Responses to RAI Questions Related to HBU Cask

Attachment 1 provides the consolidated responses to the NRC's RAI related to the High Burnup Cask Project at North Anna Power Station

**North Anna Power Station ISFSI
Virginia Electric and Power Company**

**Figure 6.5-1:
Radial Locations of the Thermocouple Lances in the TN-32B HBU Cask**

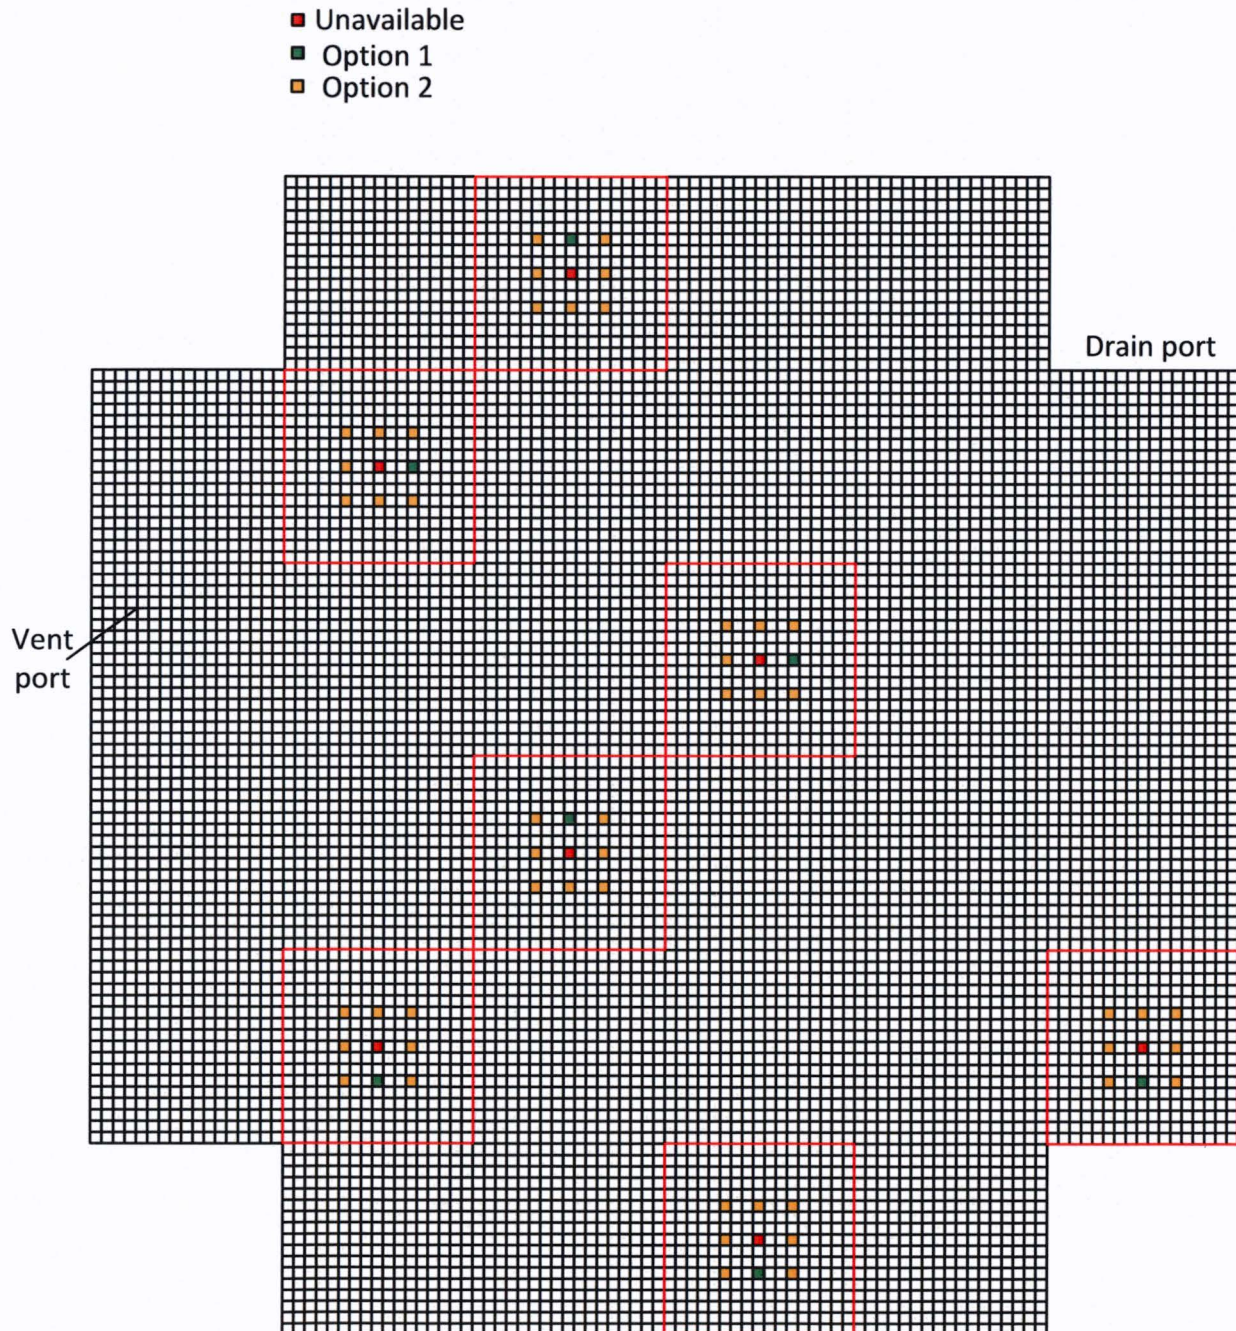
5. Clarify if the installed thermocouples will adequately capture the maximum fuel cladding temperature.

Page 8 of E-42038 states that a number of thermocouple lances will be installed in specific assemblies. However, the licensee does not provide any details on the number of thermocouples per lance location.

For the seven radial locations, there are two in the center of the cask, two in the middle, and three on the periphery of the cask (see Figure 6.5-1). For each assembly with a thermocouple lance, the specific guide tube to insert the lance into was selected to provide data of the best value from a research perspective, and was chosen considering the burnup distribution within the assembly and the predicted rod location of the peak temperature. For ease of design and installation, guide tubes were selected from one of the eight inner guide tubes. The seven radial locations are shown in the figure below as "Option 1" (green locations).
